THREE MILE ISLAND NUCLEAR STATION, UNIT 1

DOCKET NO. 50-289
OPERATING LICENSE NO. DPR-50
TECHNICAL SPECIFICATION CHANGE REQUEST NO. 6

Technical Specification Change Request No. 6

FIGURE 3.1-1

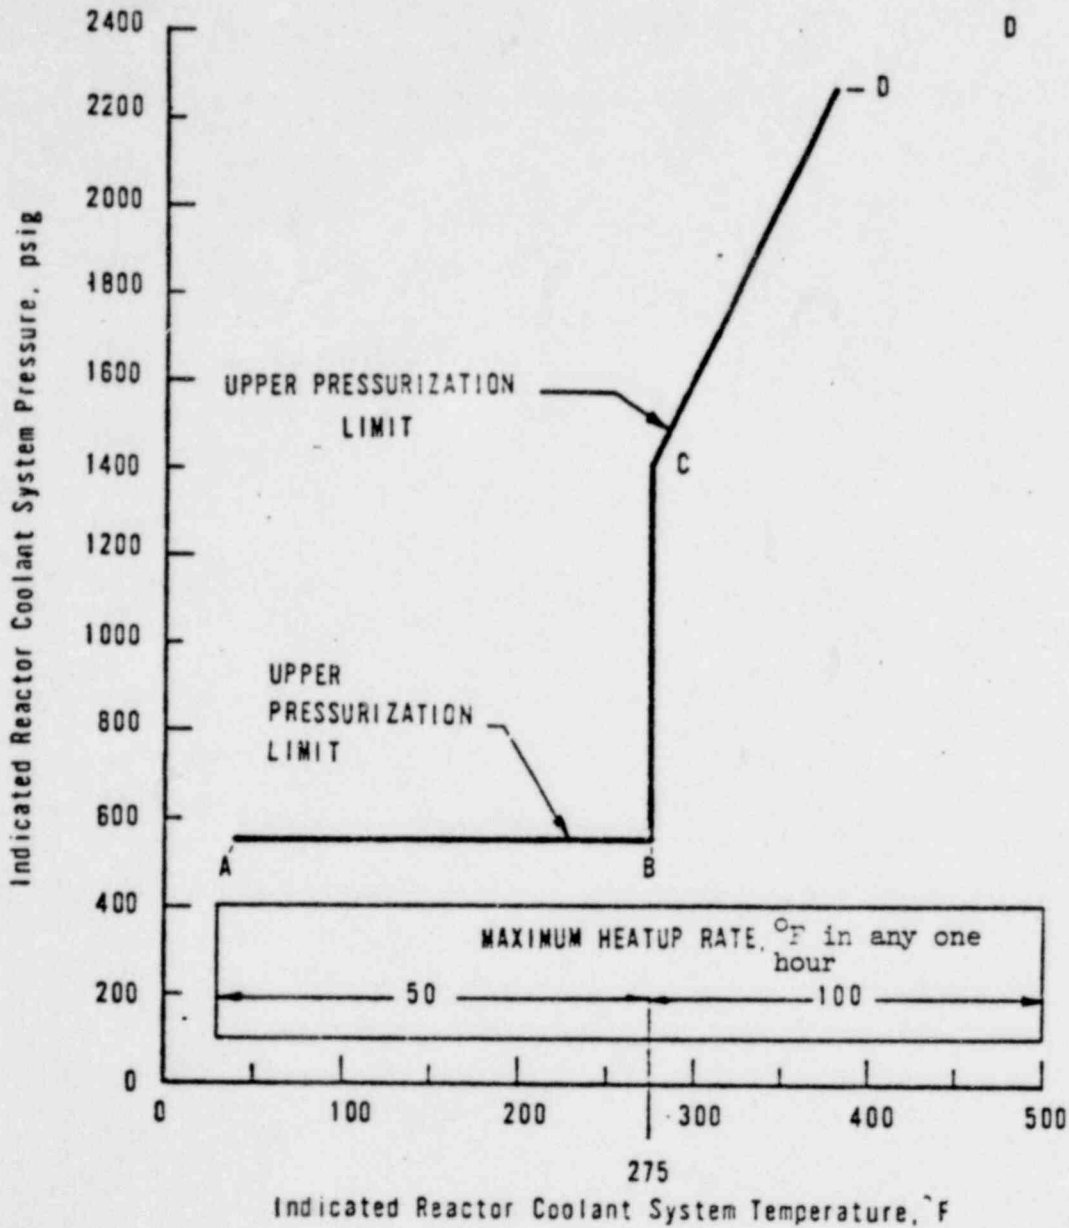
Figure 3.1-1: Change "°F/hr" on abscissa of graph to "°F in any one hour".

FIGURE 3.1-2

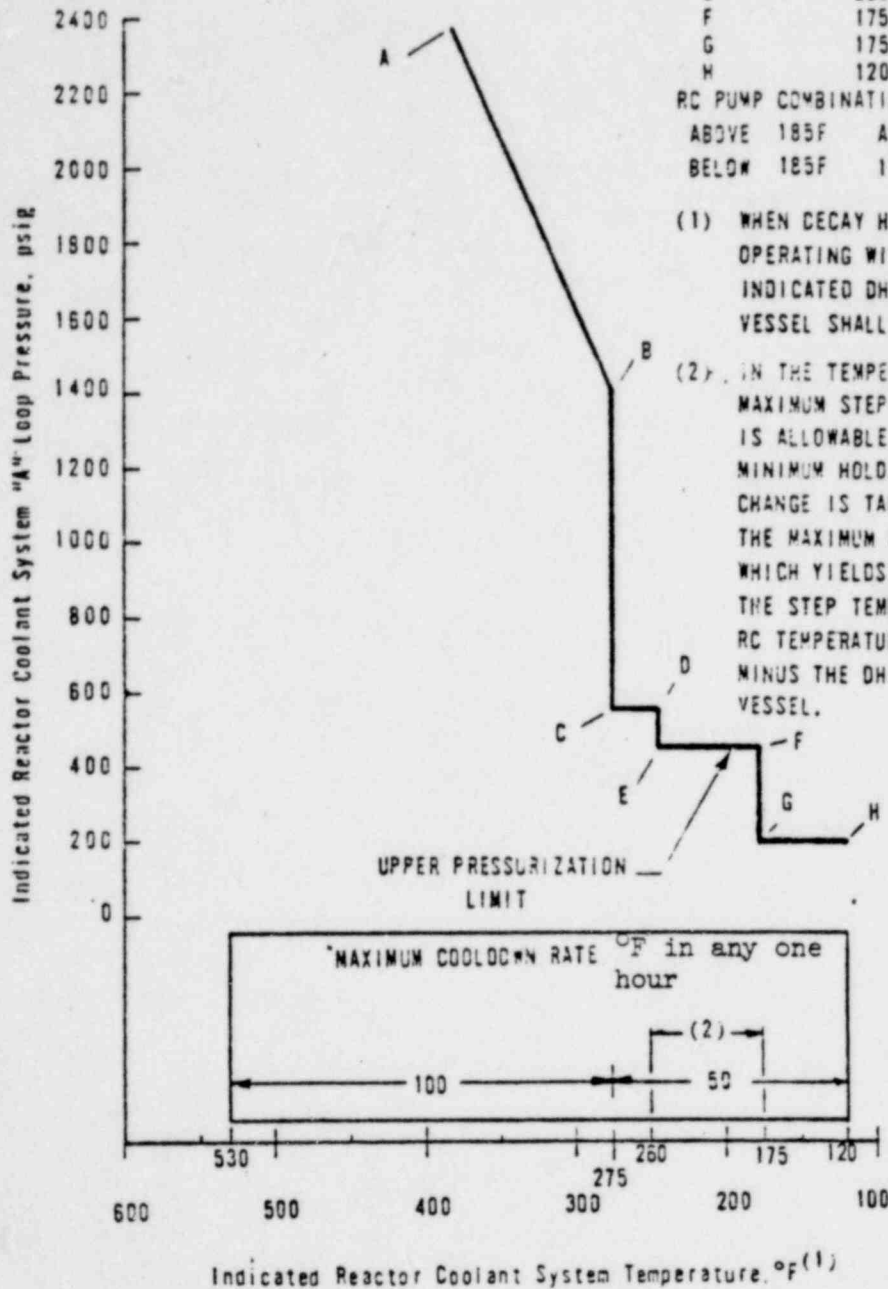
Figure 3.1-2: Change "°F/hr" on abscissa of graph to "°F in any one hour".

Acceptable Temperature Transients

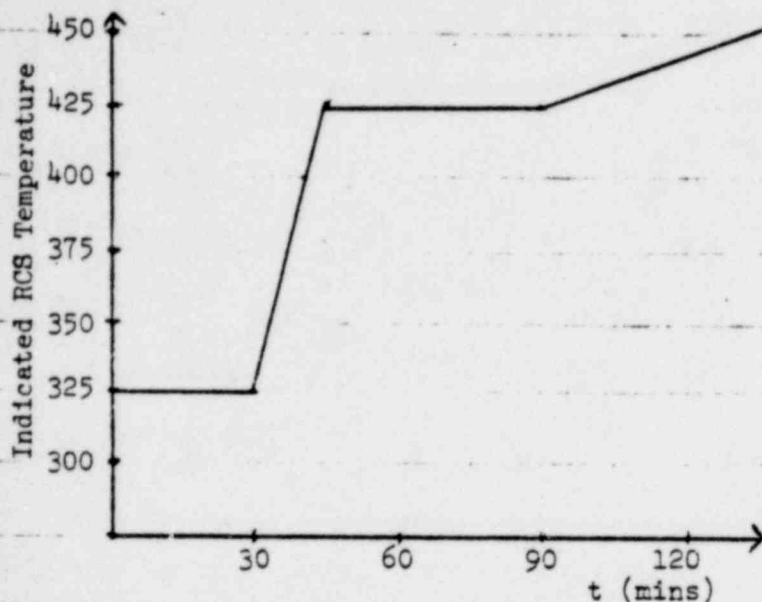
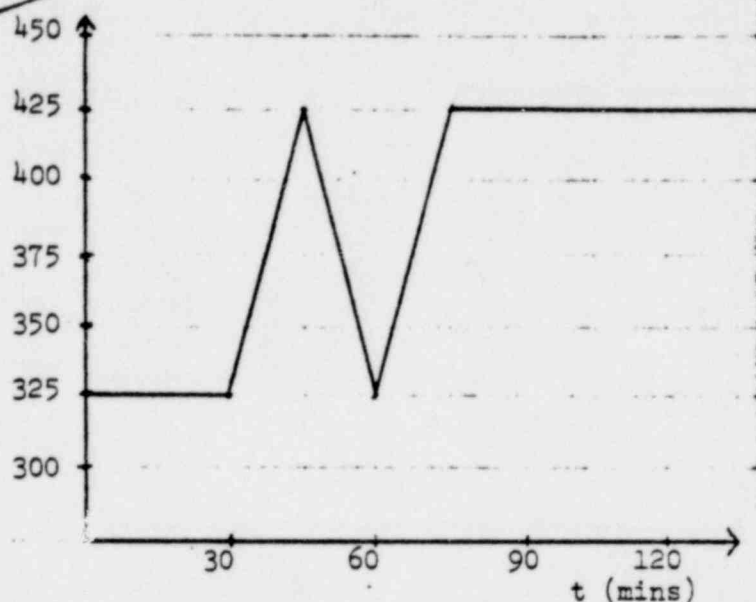
Both cases A and B are acceptable in that there exists no one hour interval, or sub-interval thereof, in which greater than a 100°F temperature increase takes place.

Non-acceptable Temperature Transients

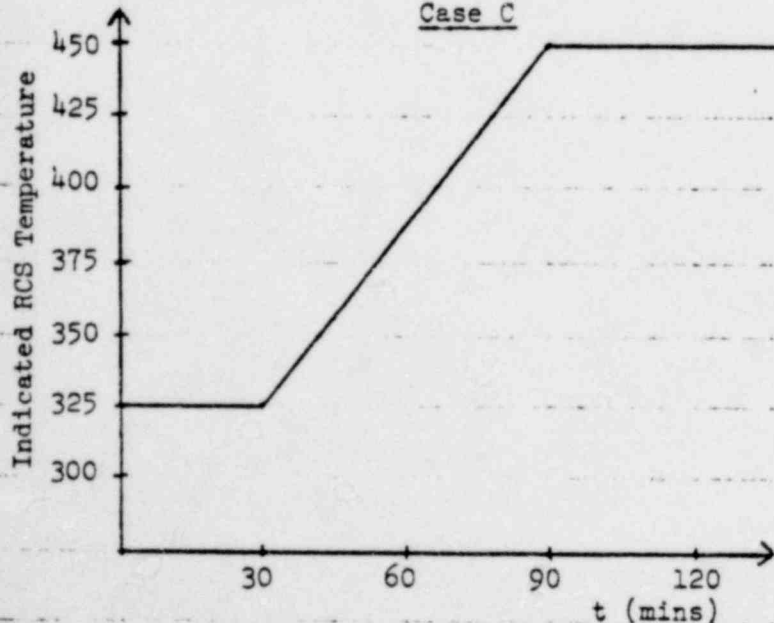
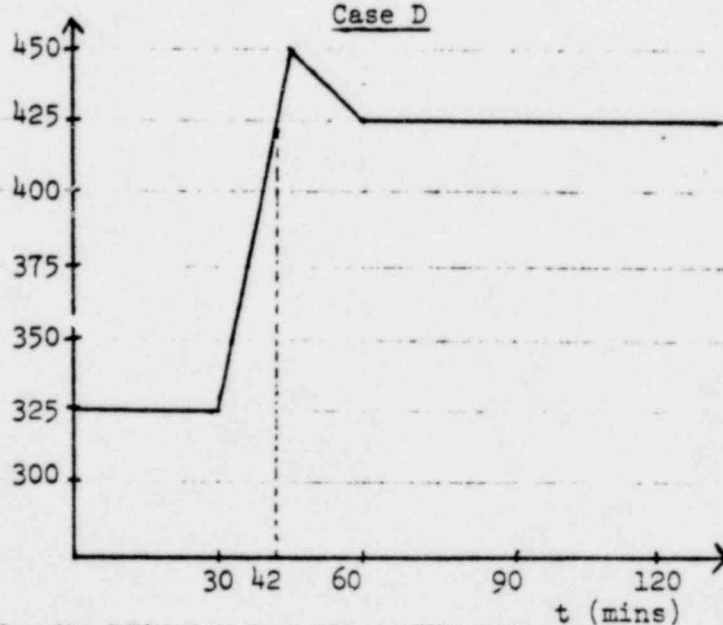
Case C is unacceptable in that over the time period from 30 to 90 minutes, greater than a 100°F temperature change takes place.

Case D is unacceptable in that there exists one hour intervals that contain sub-intervals in which the temperature change is greater than 100°F (e.g., the 30 to 90 minute interval contains many sub-intervals during which the temperature increase is greater than 100°F ; i.e., 30 minutes to any time t such that $42 < t < 60$ minutes constitute one set of such sub-intervals).
